# LARAMIE COUNTY CLERK BOARD OF COUNTY COMMISSIONERS AGENDA ITEM PROCESSING FORM

TITLE: Review and action of a Subdivision Permit and Plat for North Range

Business Park, 9th Filing, a replat of Lot 4, Block 10, North Range Business

Park, 3<sup>rd</sup> Filing, Laramie County, WY.

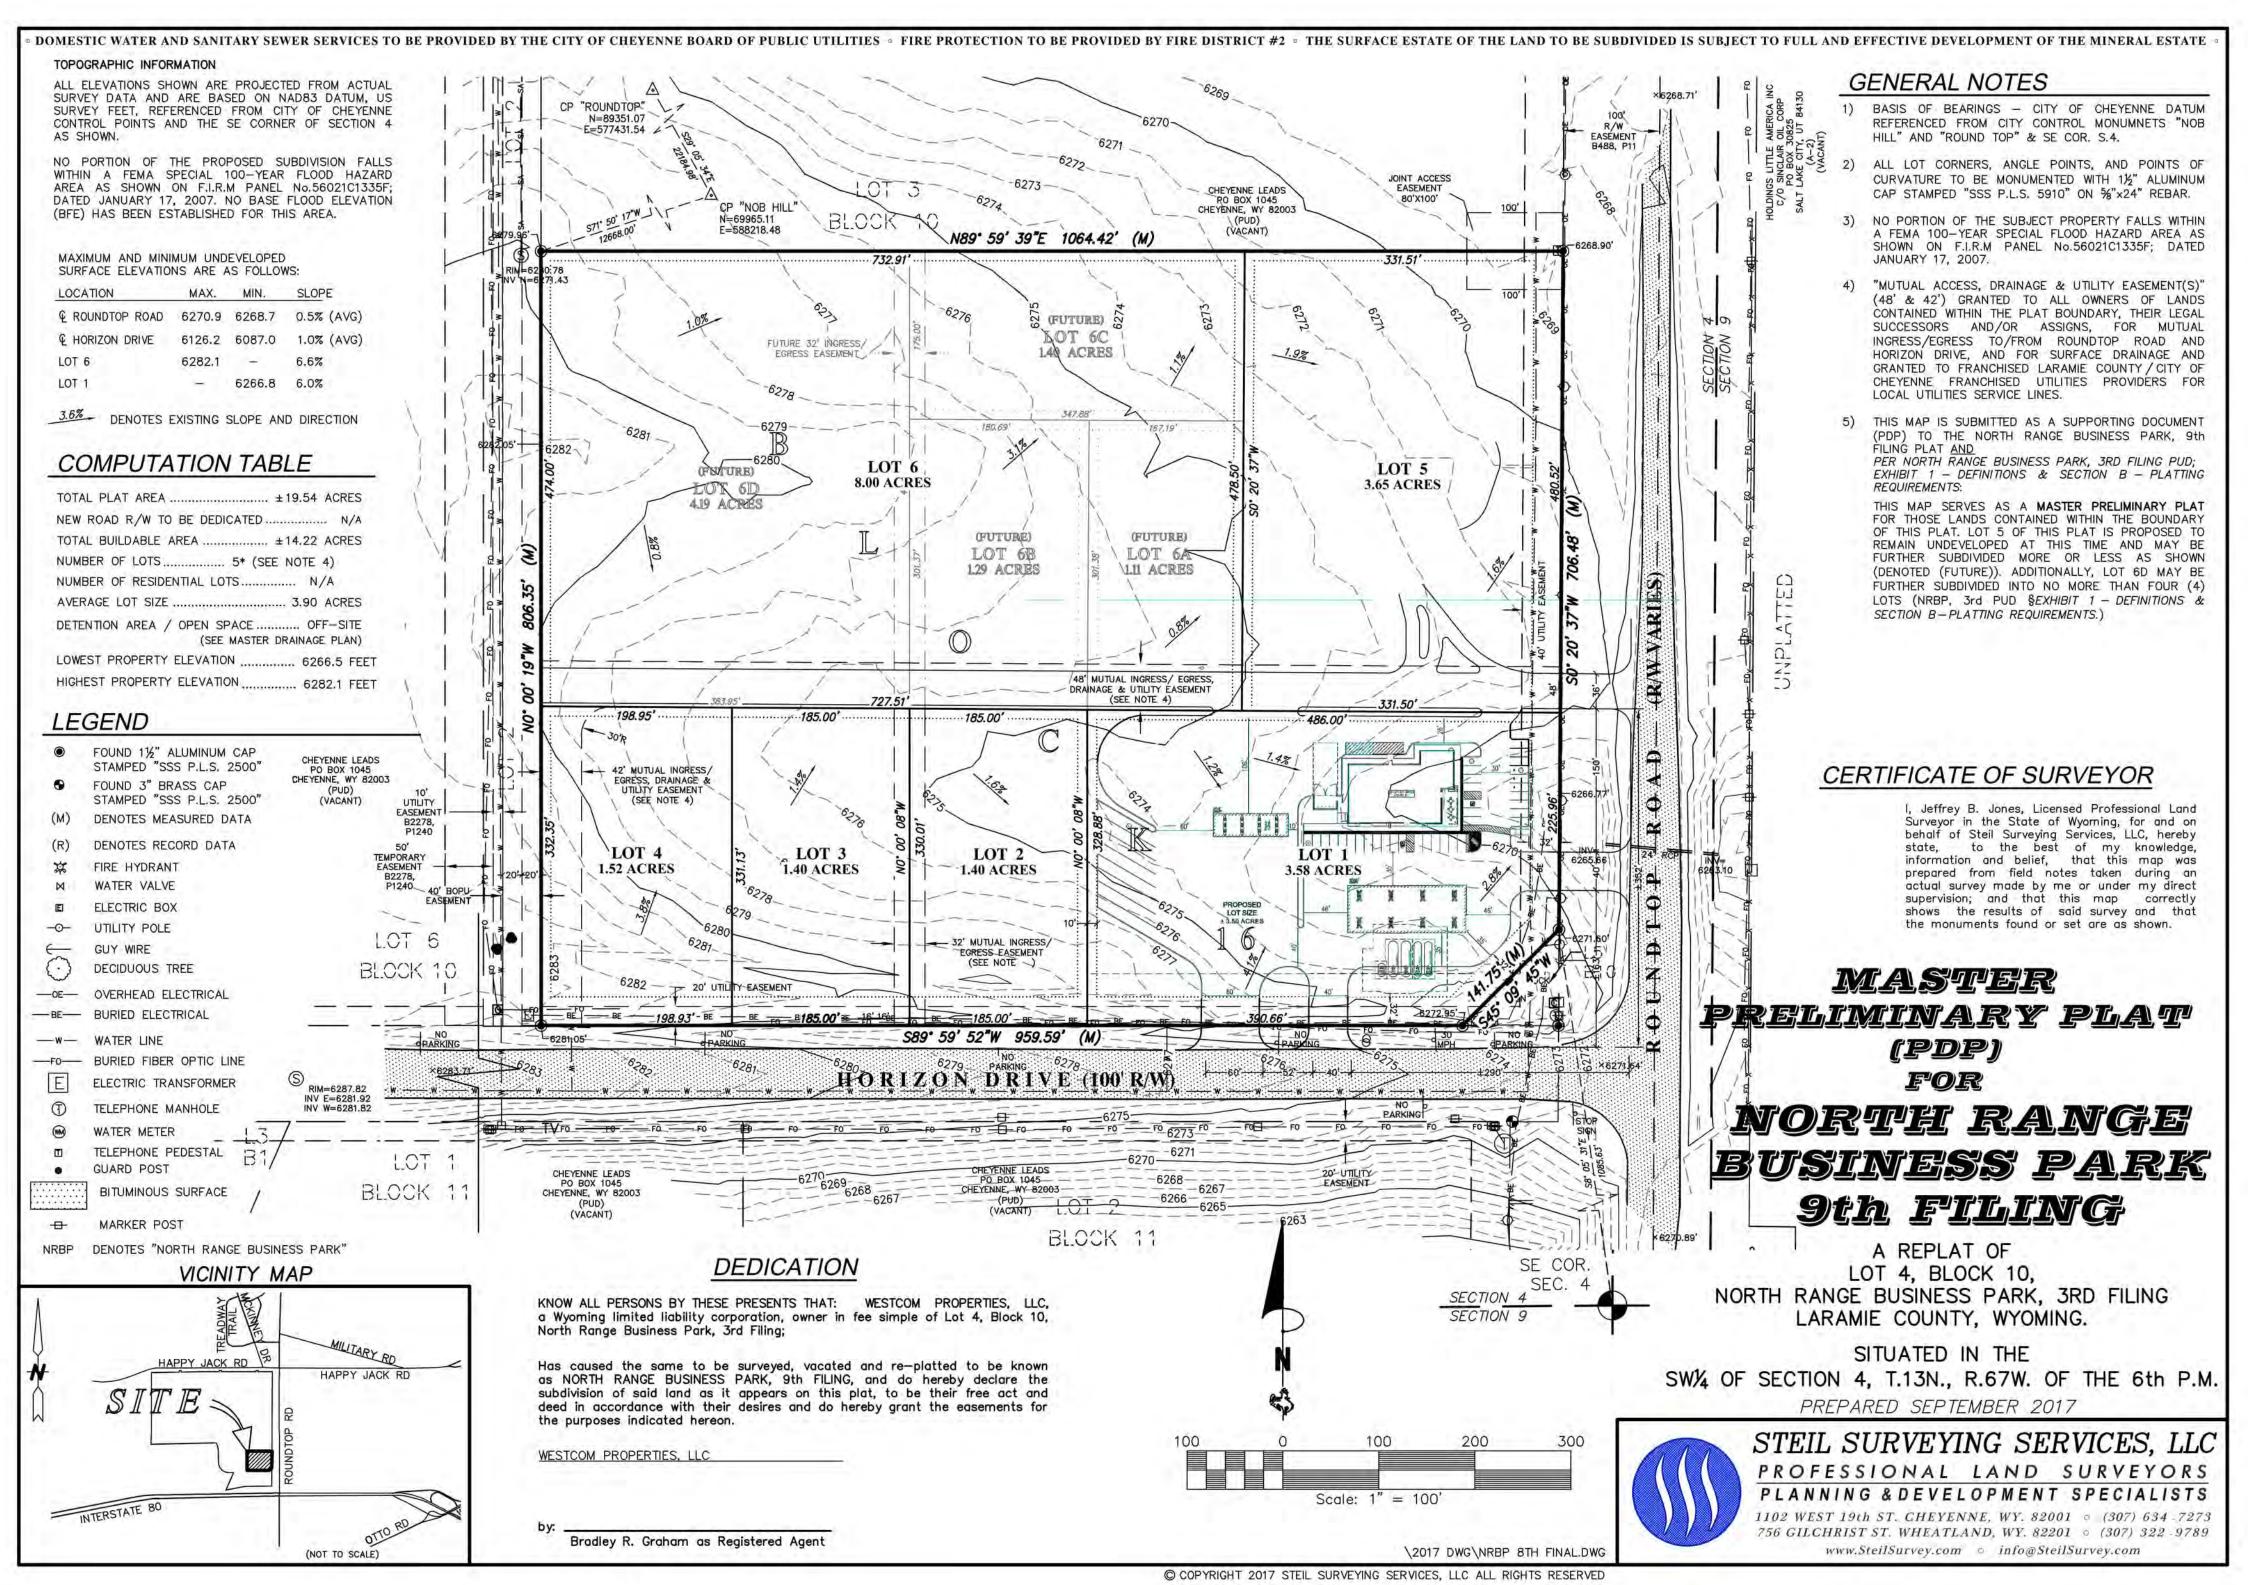
Per WYDOT access policy, spacing on an urban arterial or collector with speeds of 50 mph or above (Roundtop is posted at 55 mph) needs to be 1320 ft between public streets and commercial access. The spacing can be reduced to 660 ft if a continuous left turn lane is in place on the highway. The proposed access points to the North Range Business Park, 9th Filing, do not meet this criteria. A single access point north of Lot 5 (joint access with the lot to the north of the 9th filing) could be accommodated if a continuous left turn lane is constructed.

Lowering the speed limit to 45 mph would decrease the required spacing by half (330 ft if a continuous left turn lane is in place.) Any reduction is speed limit would require a speed study to justify the proposed limit. If this takes place, we would want to see the speed profile for the full length of Roundtop Rd between Otto Rd and Happy Jack Rd. Speed counters could be used to obtain the speed profile, but spot speed analysis of free-flow vehicles would also be necessary for the review.

The T.I.S. indicated signalized intersections will be required in the future at the I-80 ramps and at Horizon Dr. WYDOT does not have a mechanism to collect payment for future improvements, we may need to rely on agreements that can be put in place by the County or by LEADS. Spacing of signalized intersections will also be an issue. For any speeds above 30 mph, the signal spacing required in the access policy is one-half mile. Horizon Dr is located approximately 750 north of the I-80 westbound ramp intersection. Alternate intersection designs may need to be considered.

#### Planner: Nancy Trimble COMMENTS ATTACHED 10/19/2017

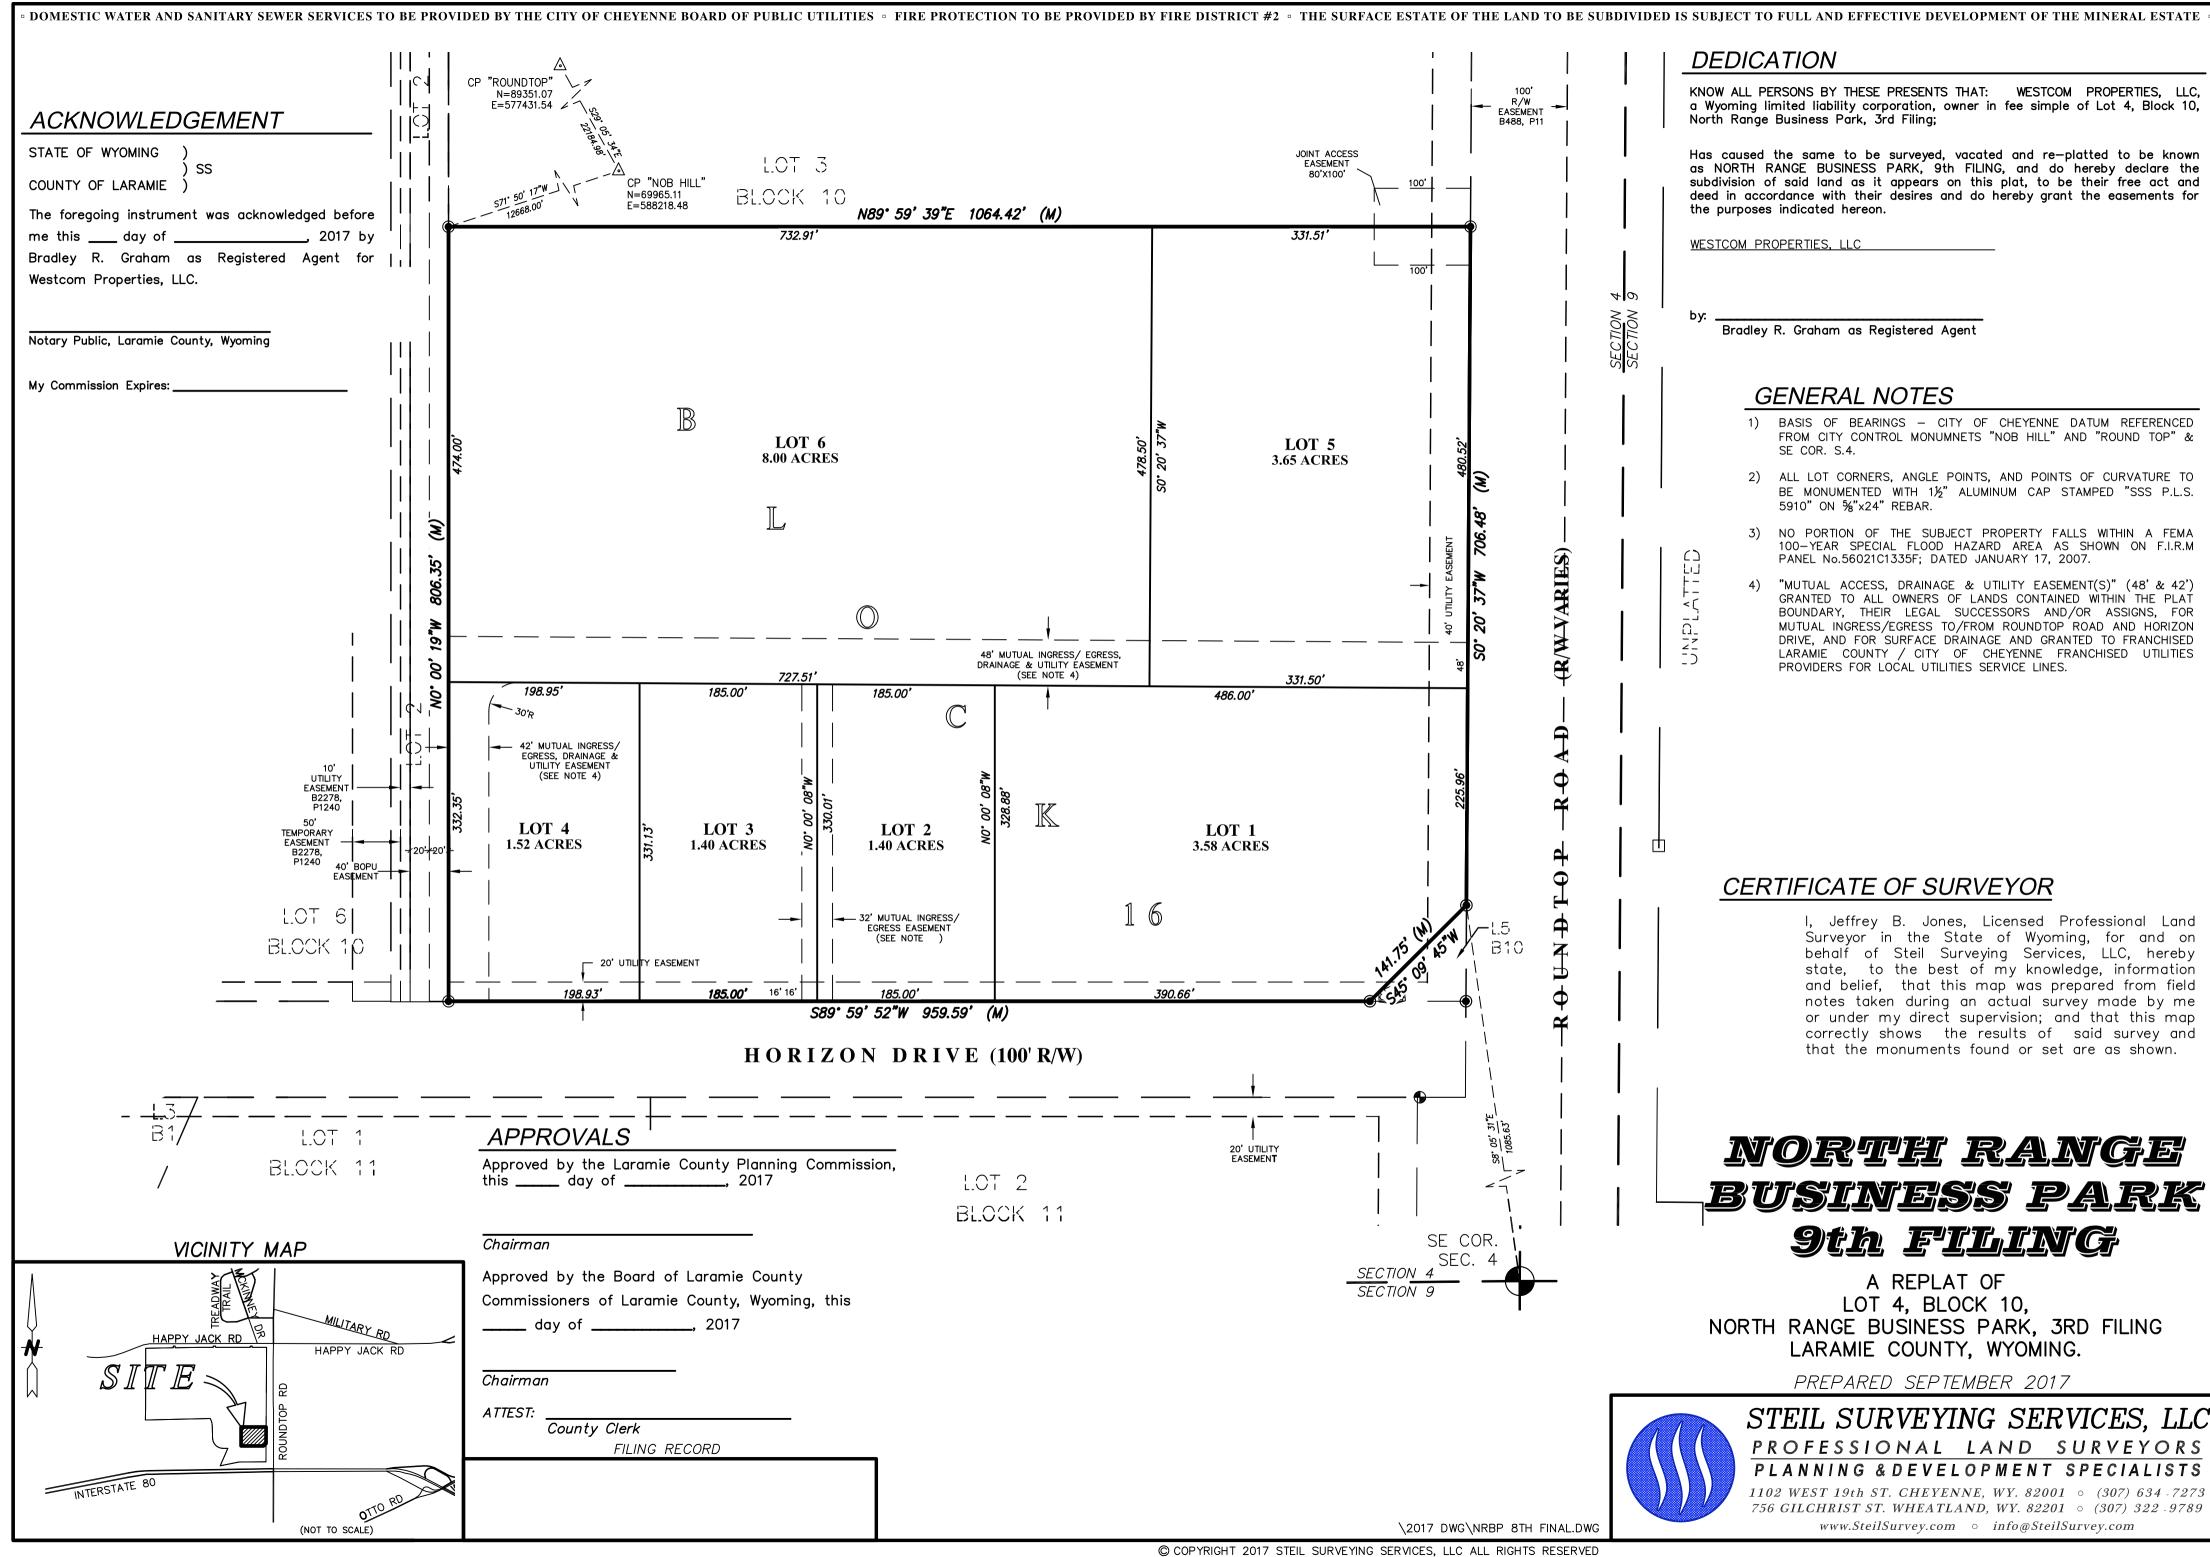
- 1) In Note 4 of the "General Notes" section on the plat, add the language "with approved approach permit from WYDOT" after "Roundtop Road".
- 2) Add Note # for 32' Mutual Ingress/Egress Easement between Lots 2 and 3.
- 2) Clerical errors on the plat shall be corrected prior to recordation.
